# Groundwater Transfer Review Summary Form

Transfer/PA # T- 14642

Application: T-14642

Applicant Name: Oregon State University Cascades

Transfer Map

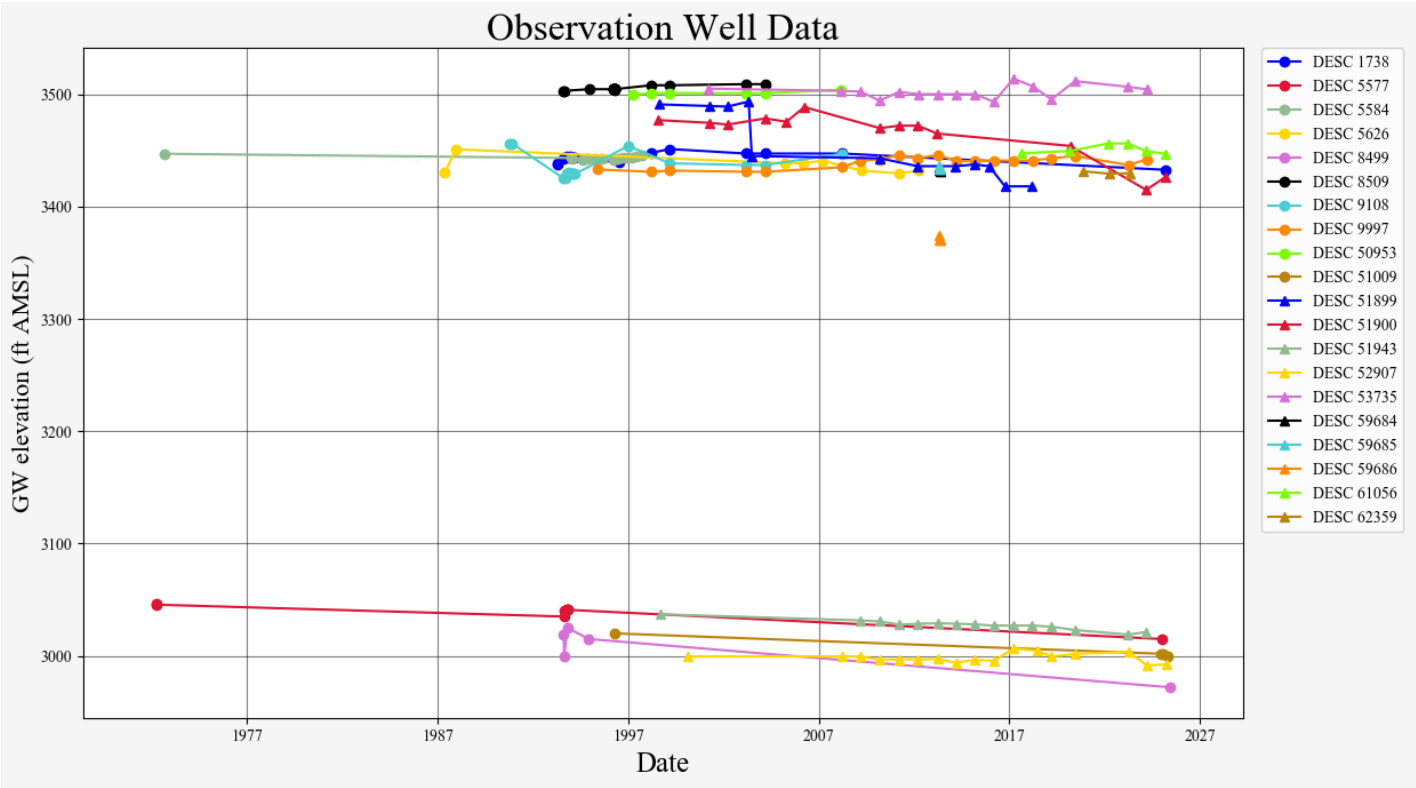
2. Will the proposed POA develop the same aquifer (source) as the existing authorized POA?  
☒ Yes ☐ No Comments: The current POAs access the Deschutes regional aquifer where it is hosted in Quaternary-aged lavas and tuffs erupted from the Cascades. The proposed POA is only 650 feet away from the current production well and will access the same geology and groundwater source.

6. a) Will this proposed change, at its maximum allowed rate of use, likely result in an increase in interference with **another surface water source**?  
☐ Yes ☒ No Comments: The proposed APOA is 650 from the current production well. The target aquifer is disconnected from adjacent surface water sources until groundwater begins flowing into the Deschutes and Crooked rivers in the confluence zone (located ~25 miles to the north). The change in well location is negligible when considering the distance to the next point of GW-SW interaction. Additionally, the permitted use is non-consumptive, so there is not expected to be a resulting stream depletion signal.
